Hornsea Project Three  
Offshore Wind Farm

### Applicant's Comments on the Report on the Implications for European Sites (RIES)

Date: 14<sup>th</sup> March 2019

Figure 2.1: Large Shallow Inlets and Bays Annex I feature of the Wash and North Norfolk Coast SAC (from Magic.defra.gov.uk) with Hornsea Three offshore cable corridor.

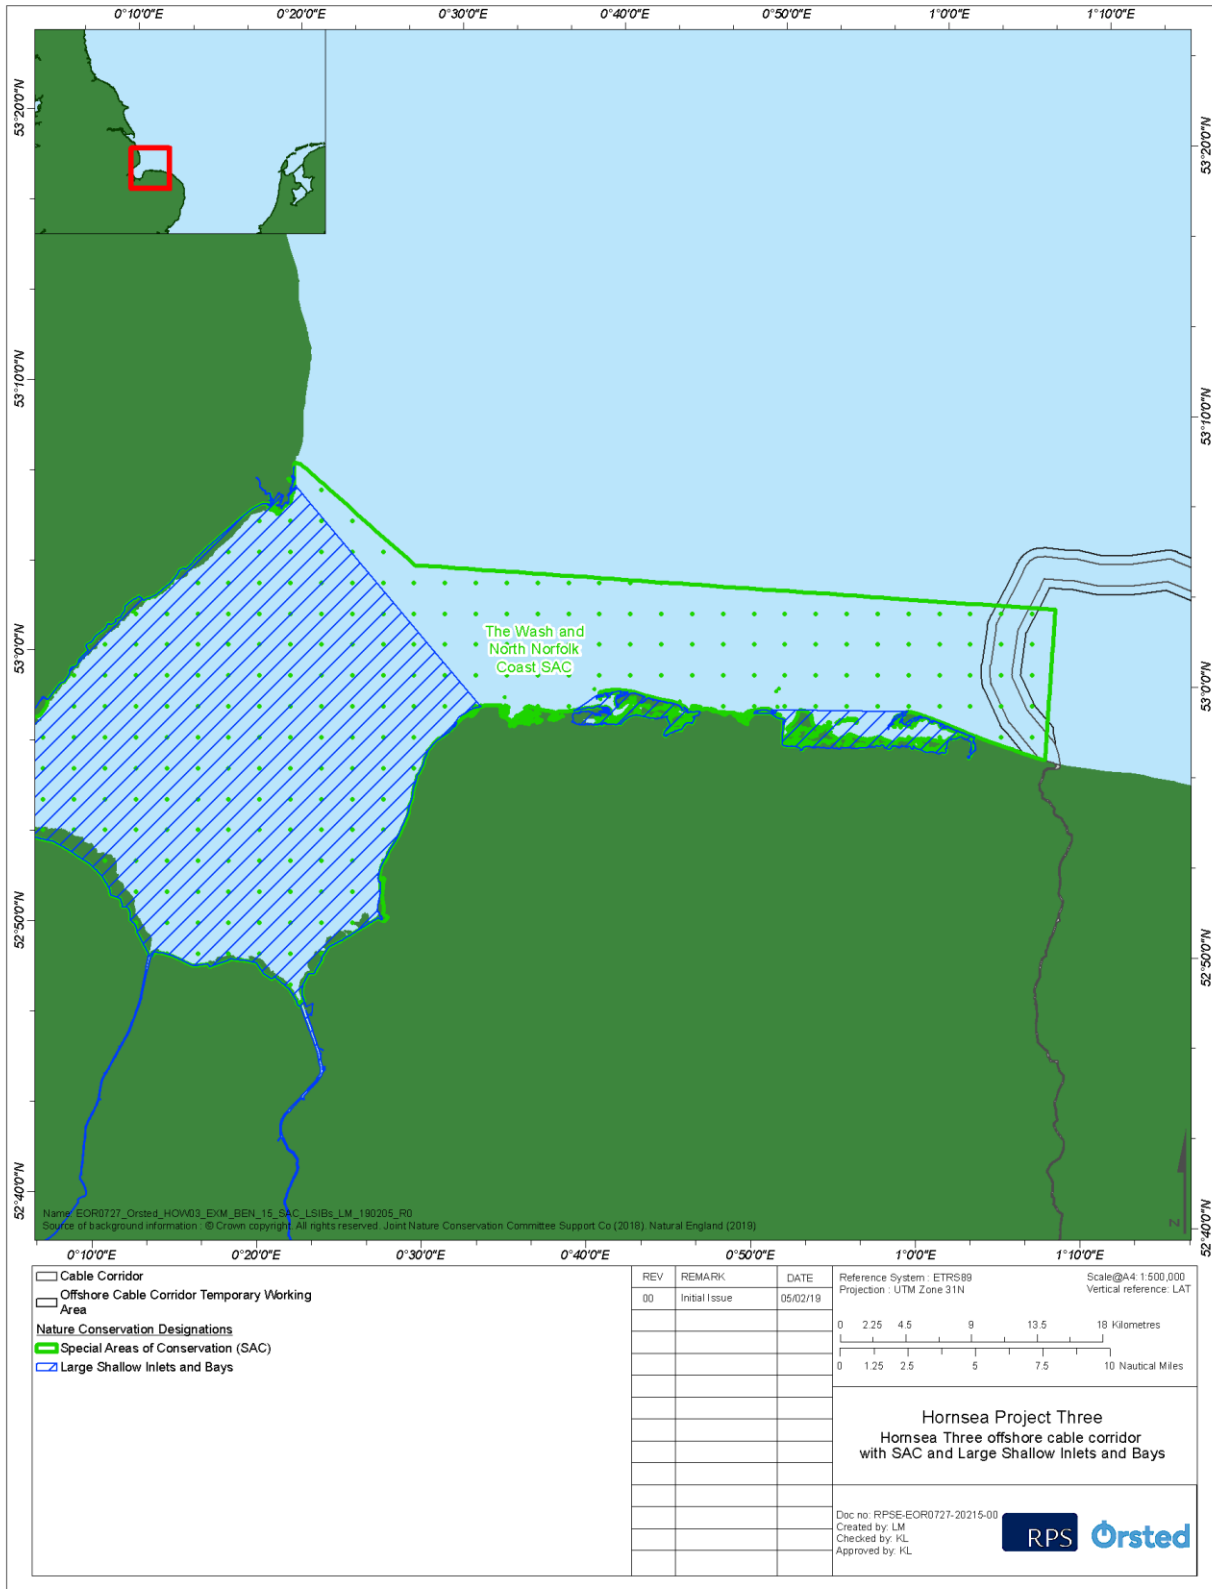
Note j	<p>See comments on Stage 2. Matrix 1, note j.</p>
Note k, paragraph 2	<p>See comments on Stage 2. Matrix 1, note k, paragraph 2 in relation to combined effects of different phases of development.</p> <p>With regard to the note that NE has queried whether the in -combination assessments includes the Race Bank marine licence applications, the Applicant provided responses to the NE submission at Deadline 6 (REP6-051), including outlining why it was not necessary to include the Race Bank marine licence application MLA/2017/00277/4 in the in-combination assessment (i.e. this relates to placement of cable protection <u>outside</u> the Wash and North Norfolk Coast SAC). These clarifications are provided in the Applicant's Deadline 7 comments on Written Representations and Responses submitted by Natural England at Deadline 6.</p>
